Re: Stowe Parking Lot Improvements – Parking Lot A1, A2, A3 Expansion  
Site Plan Revisions

On behalf of VR US Holdings II, LLC, please find enclosed a revised set of the Stowe Mountain Parking Lot Improvements – A Lots Plans. As a follow-up to the 11/7/2023 DRB hearing, the plans have been revised to address feedback received both from Staff and the Board. These revisions include:

## Stowe Mountain Parking Lot Improvements - A Lots

**PLANS & ELEVATIONS**

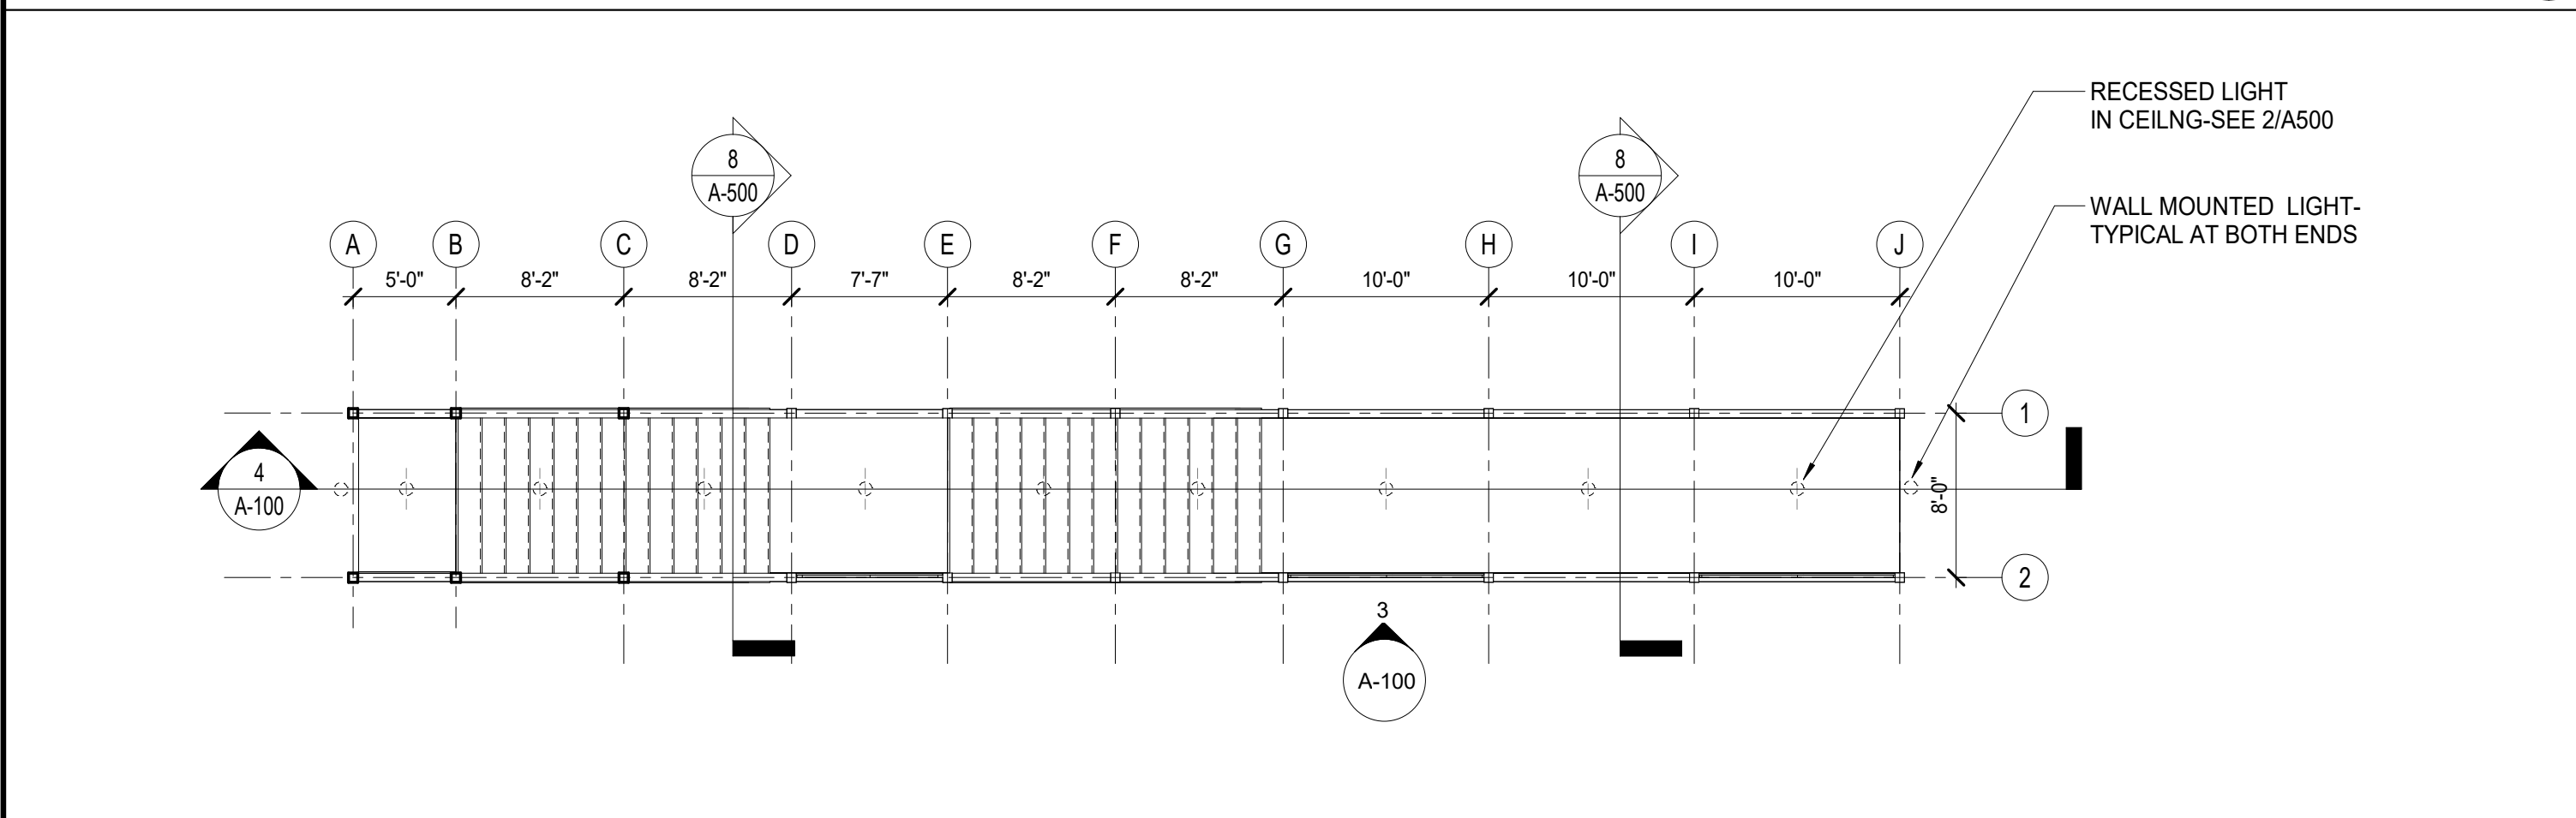
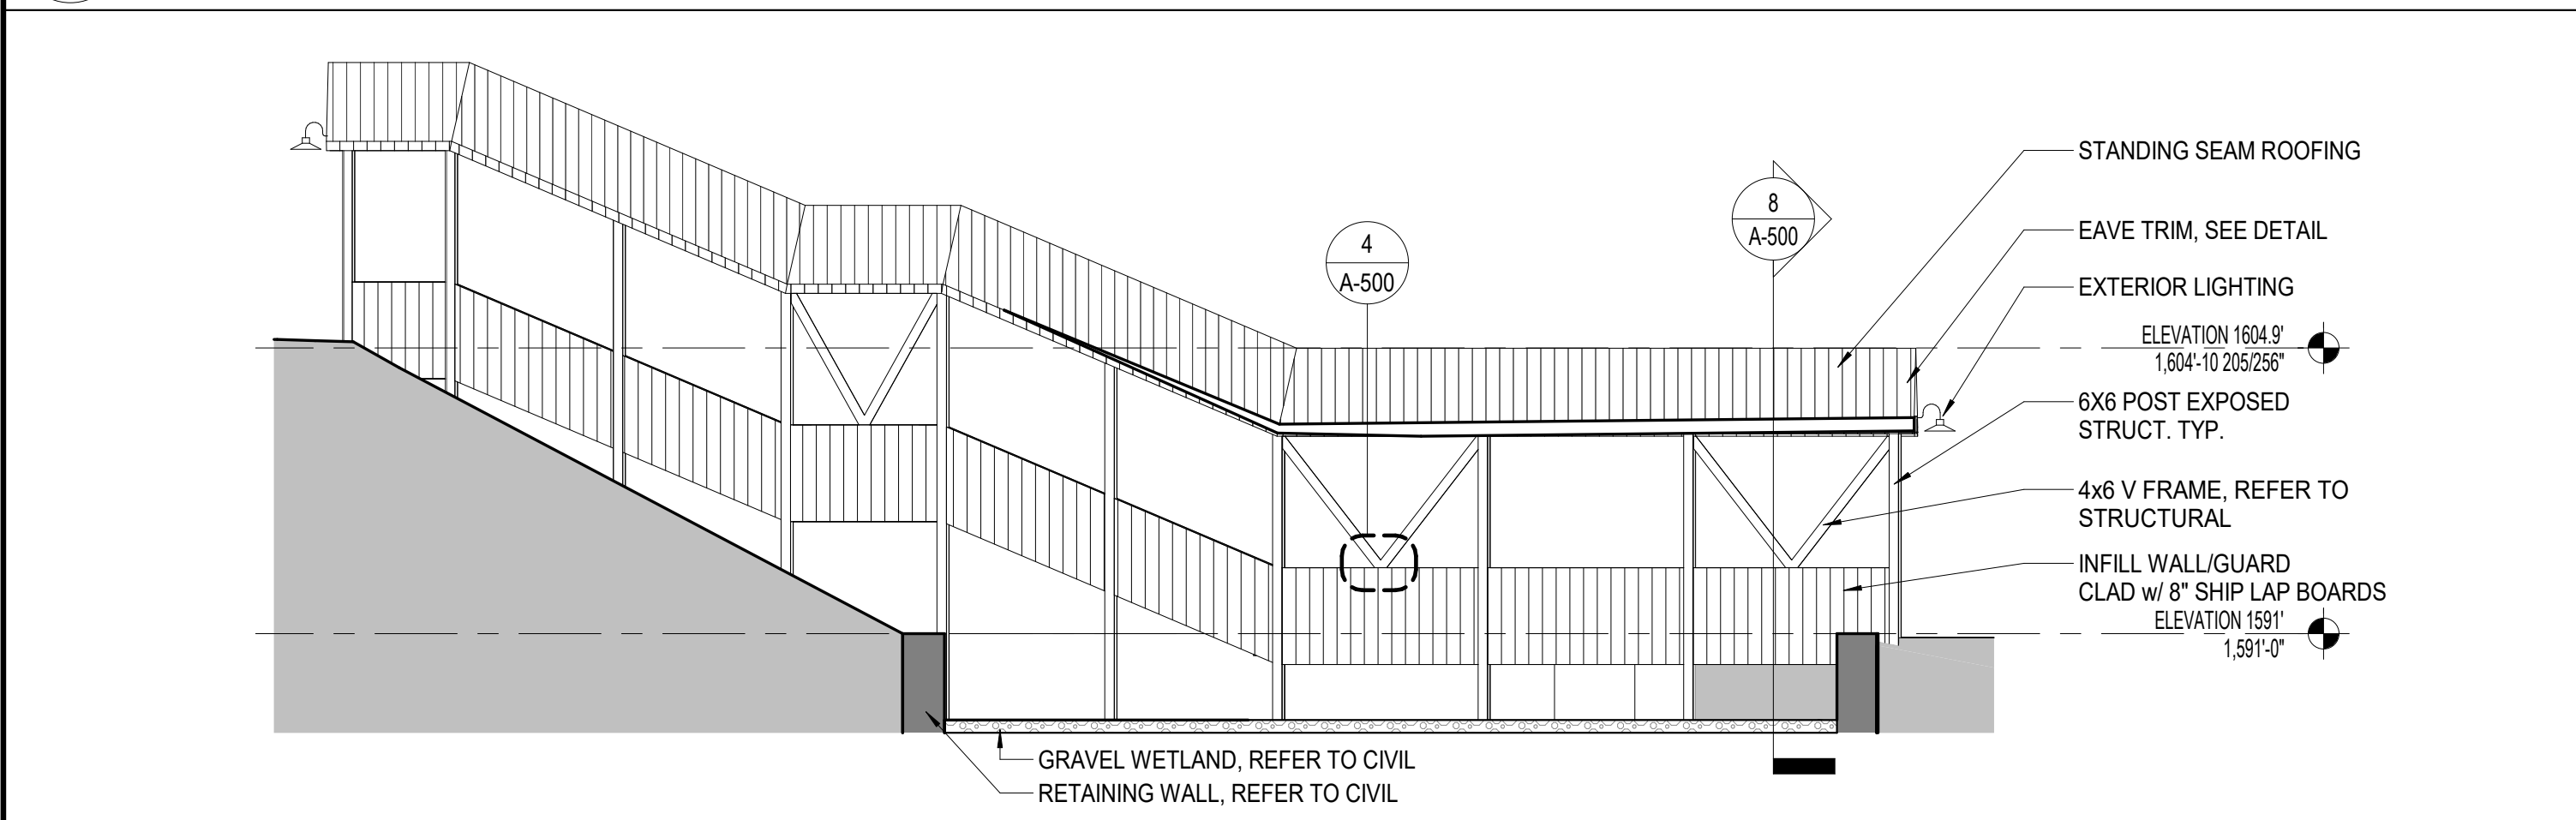
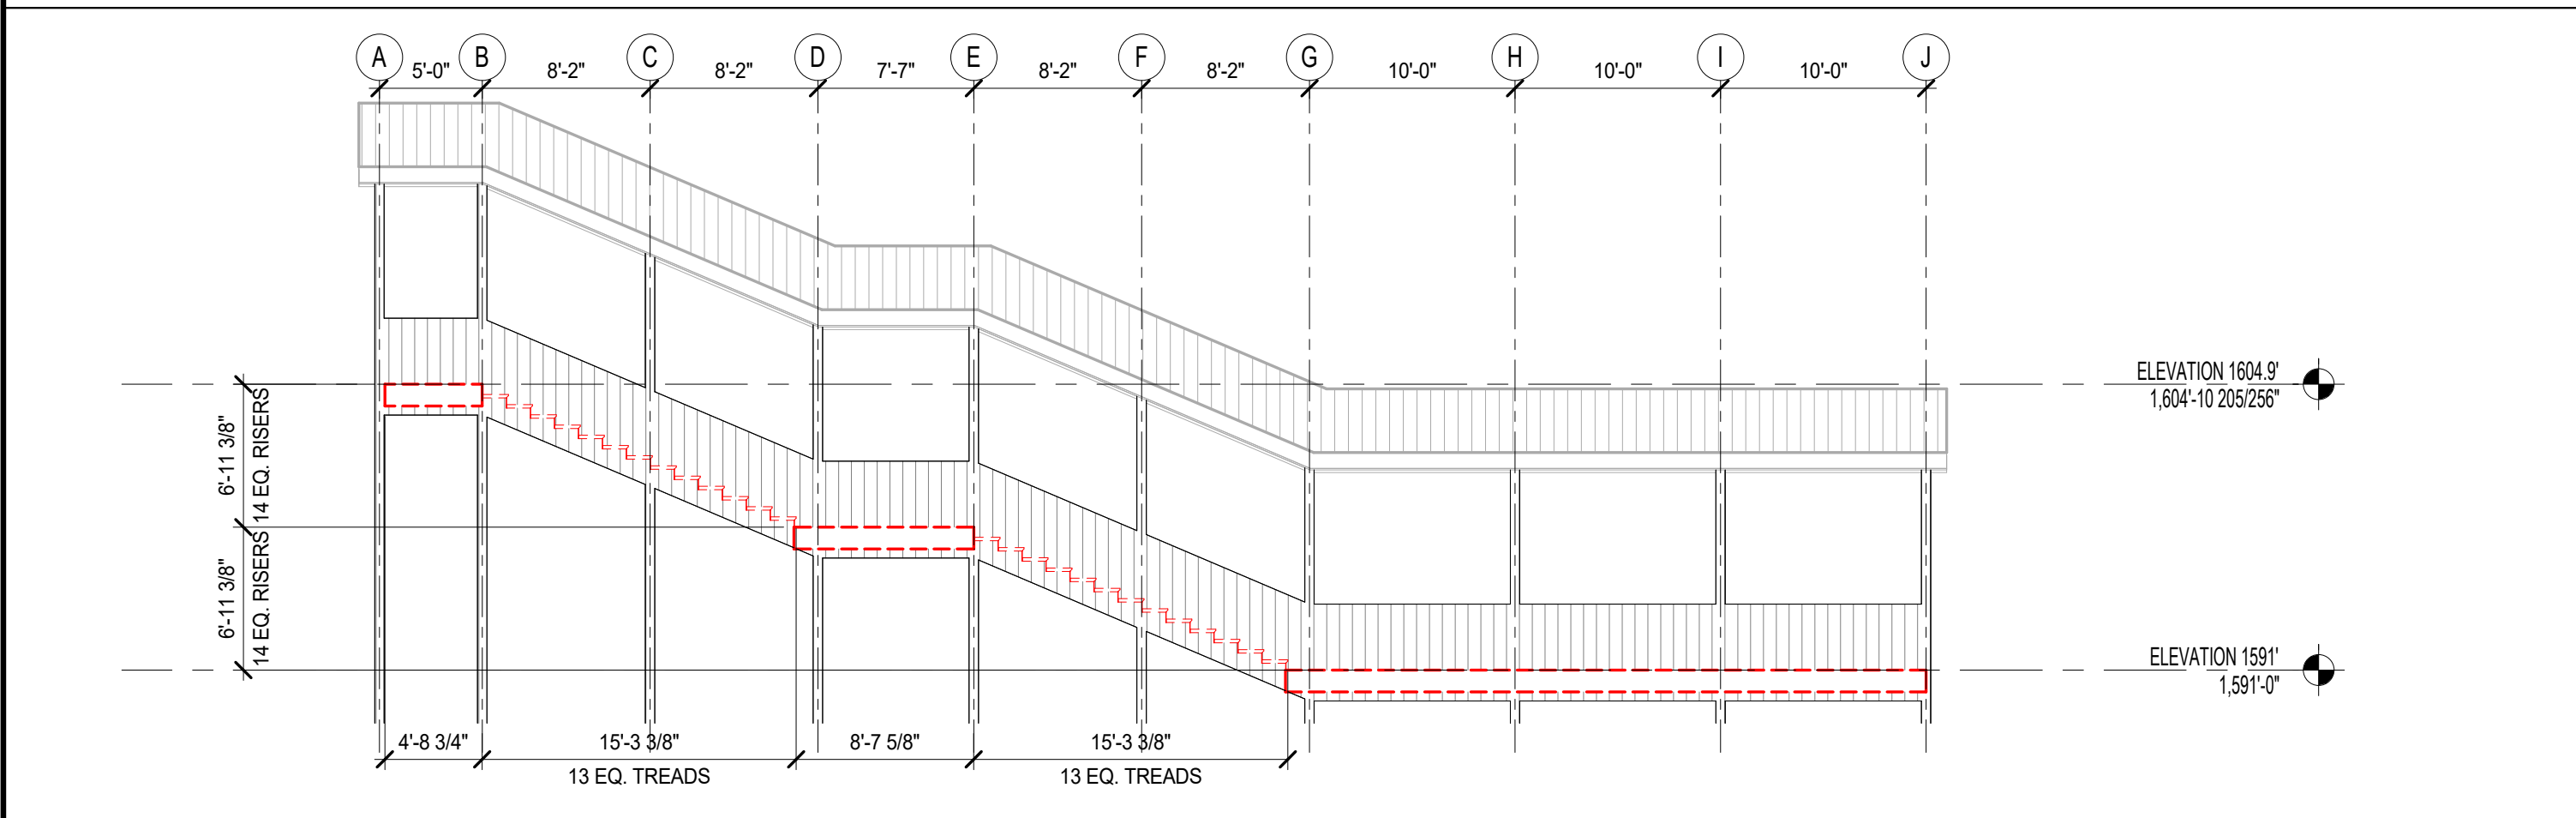
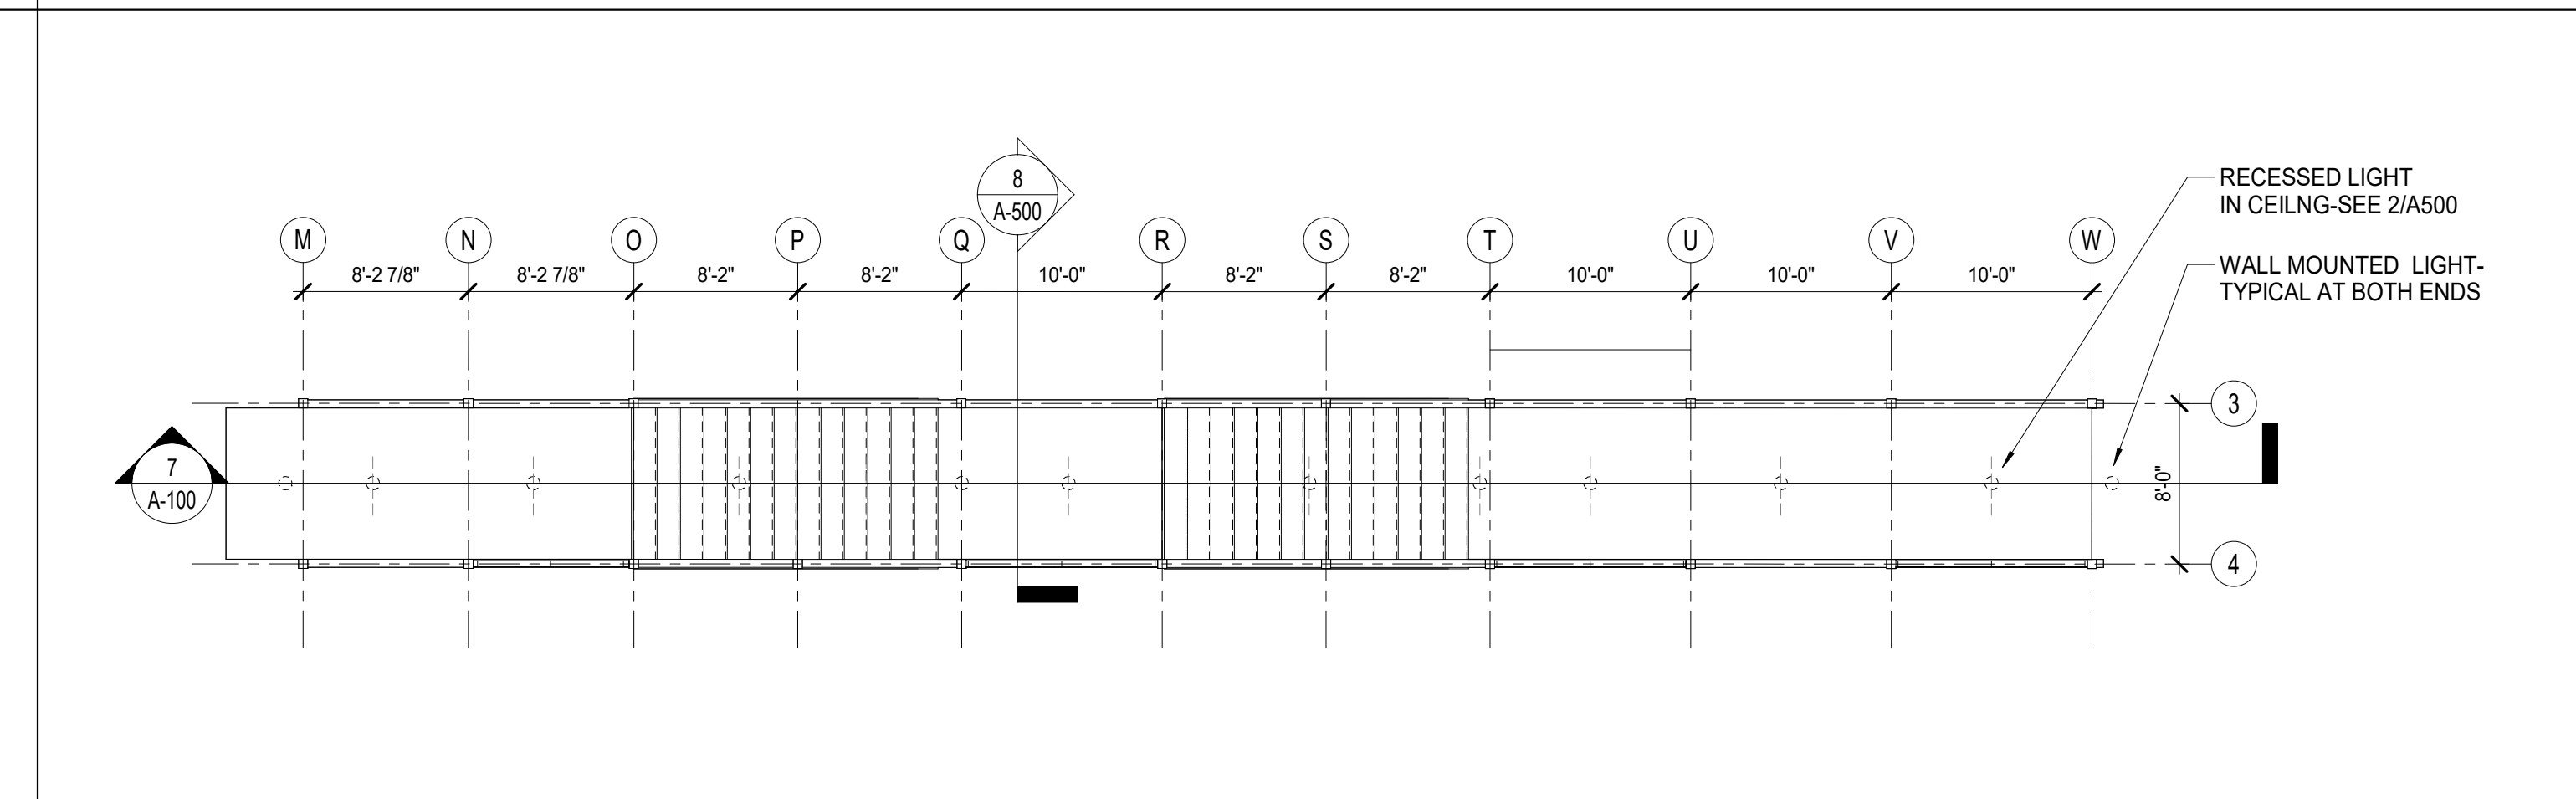
- 5) Revised Covered Stairway / Boardwalk Plans – The covered stairways and boardwalks have been revised to include recessed, ceiling mounted lighting as depicted on Sheet A-100 and A-500. In addition, exterior gooseneck lighting is proposed at each entrance / exit. Please refer to attached Parking Lot Stair Plan and light fixture cut sheets for additional information.
